Lobby Renovations
11 Lake Avenue, 40 Belmont Street,
1050 Main Street, 1060 Main Street &
275 Pleasant Street
Worcester, MA 01604
Project No. 2022-07

ADDENDUM NO. 1 01/10/2023

ADDENDUM NO.2
RESPONSE TO BIDDER QUESTIONS
January 10, 2023

To all Bidders on the Project titled: Worcester Housing Authority- Lobby Renovations and Upgrades,
12-5 Pleasant Tower, 12-8 Lincoln Park Tower, 12-12
Belmont Tower, 12-13 Webster Tower West, 12-15
Webster Tower East, Worcester, MA 01605

Sketch SK3A – Restroom Revisions, 275 Pleasant St. is attached and uploaded.

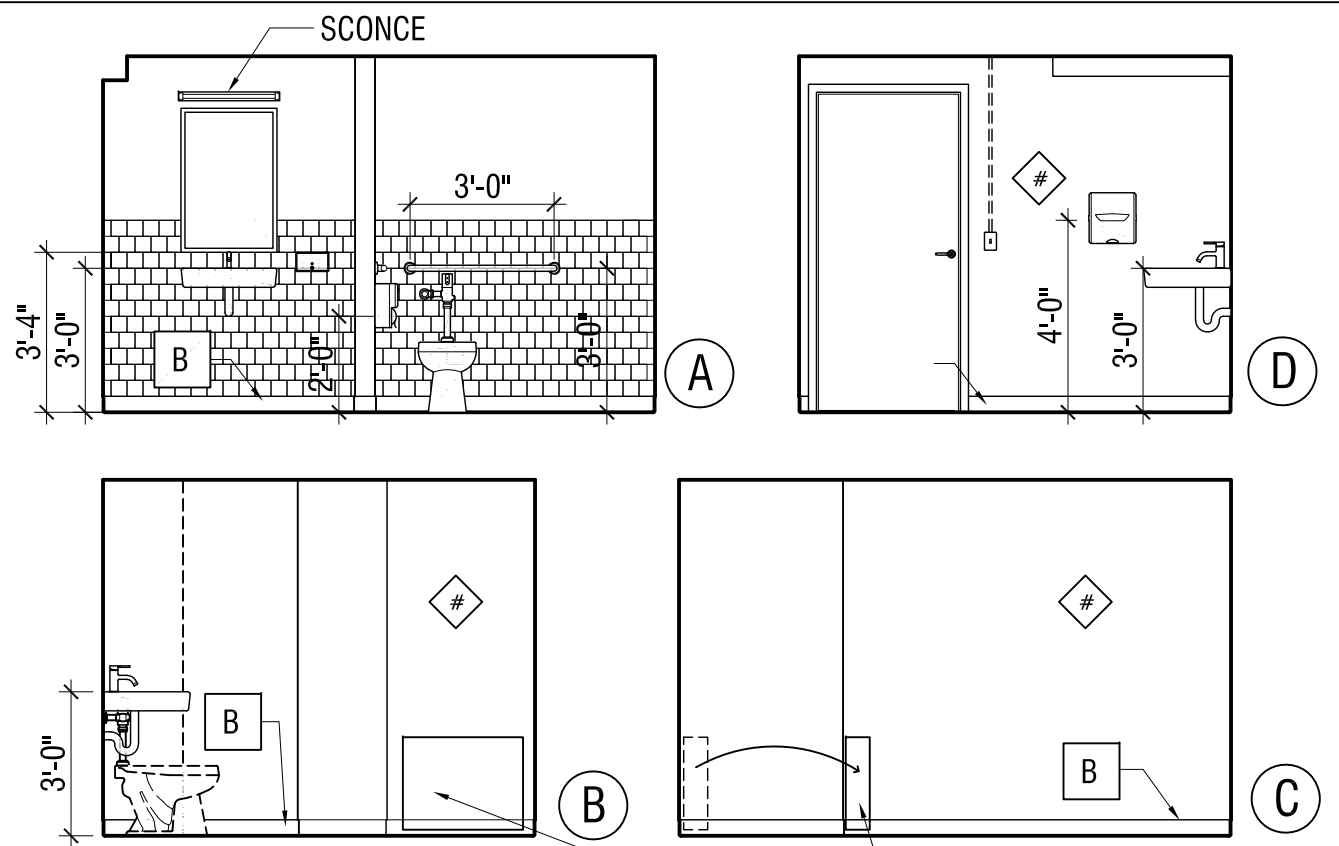
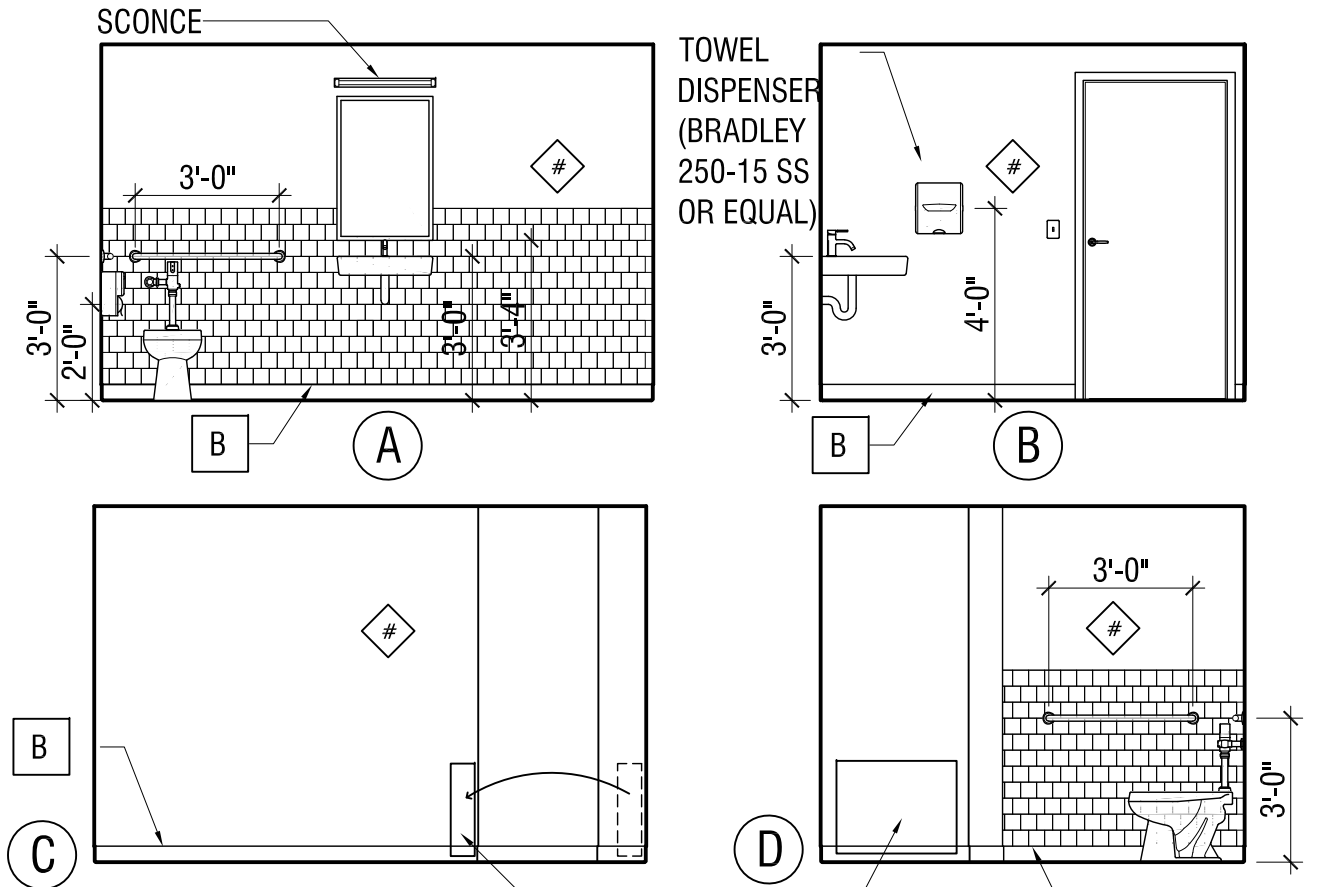
RELOCATE EXIST. HEATER

RELOCATE EXIST. HEATER
